Department
of Energy &
Climate Change

EMR Panel of Technical Experts' Final Report on National Grid's Electricity Capacity Report

June 2015

Figure 1 Indicative relation between frequency and magnitude of interruptions

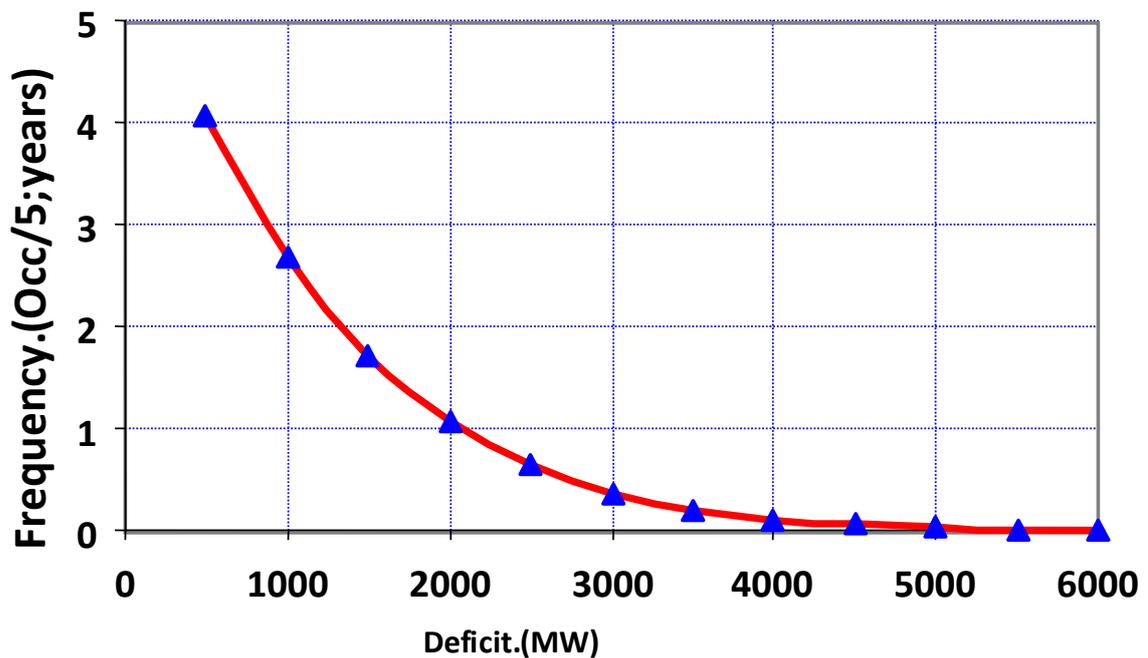
69. Based on unpublished modelling of supply interruptions in GB system carried out by Imperial College, Figure 1 indicatively illustrates the link between the magnitude and frequency of deficits (frequency is expressed as number of occurrences in 5 year period): we observe that the deficit of 500MW is expected to occur 4 times in 5 years (call it once a year), while deficit of 2000MW on average will occur once in 5 years.

70. Clearly, the deficits are relatively modest in magnitude and there will be hence opportunity to *schedule* these across the system and therefore *reduce the duration of interruptions* experienced by individual consumers leading to reduced VoLL (and hence the actual interruption costs).

Figure 2 Illustrative cost curves with and without mitigating actions costing at £6,000/MWh

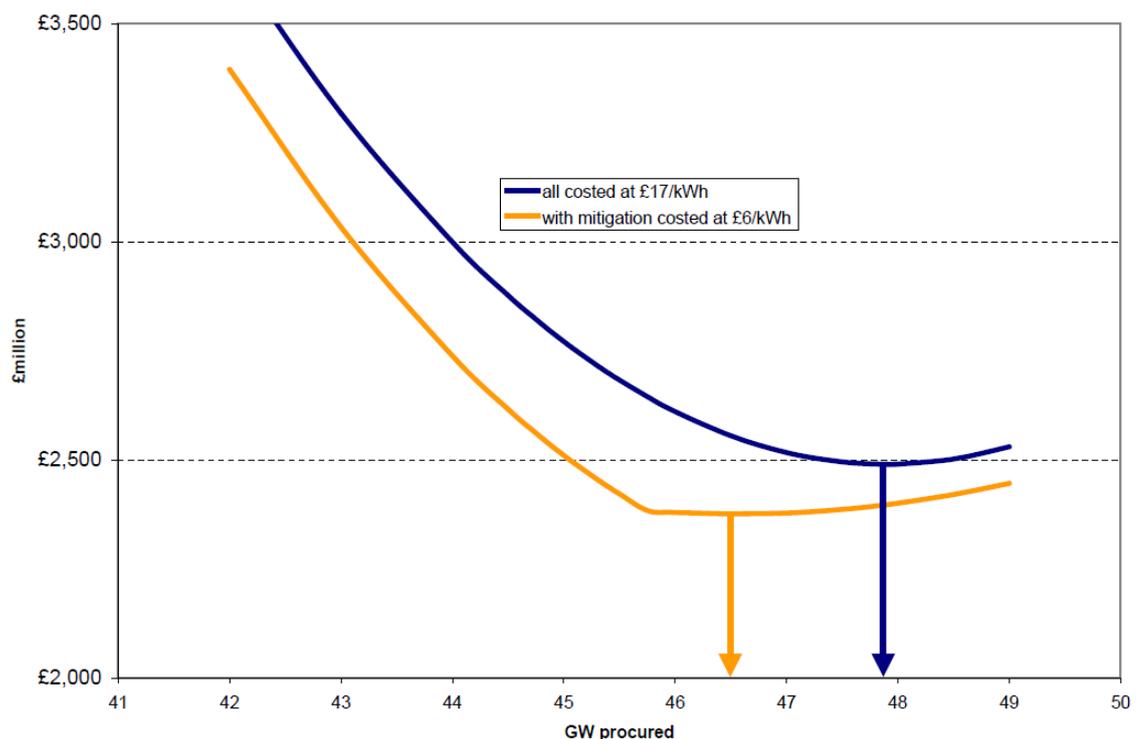
76. Nevertheless, there is some volume of so-called Loss of Load events that should be valued substantially below £17,000/MWh, and if this were done, the minimum cost point would be at a lower level of capacity under all scenarios. Figure 2 illustrates this, following the format (but not the details) of National Grid’s figure 14 for one scenario.

77. Figure 2 shows the combined cost of procuring capacity at £49/kW/yr and all energy unserved (shortfalls that the System Operator has to mitigate) at £17,000/MWh, as in National Grid's Report (the upper line), and the effect of costing 2GW of energy unserved as mitigating actions that are costed at £6,000/MWh, and any energy unserved above that at the full cost of the lights going out, at £17,000/MWh. The minimum point on the total cost curve falls from 47.9 GW to 46.5 GW in this illustrative case. For any scenario, the effect of costing the first energy unserved amounts at a cost below £17,000/MWh will necessarily lower the least cost target capacity, so we can confidently state that National Grid's determination of the least cost amount to procure is necessarily too high, regardless of which scenario is the Least Worst Regrets choice, and the size of the regret, although we cannot say by how much National Grid has overestimated the target capacity.
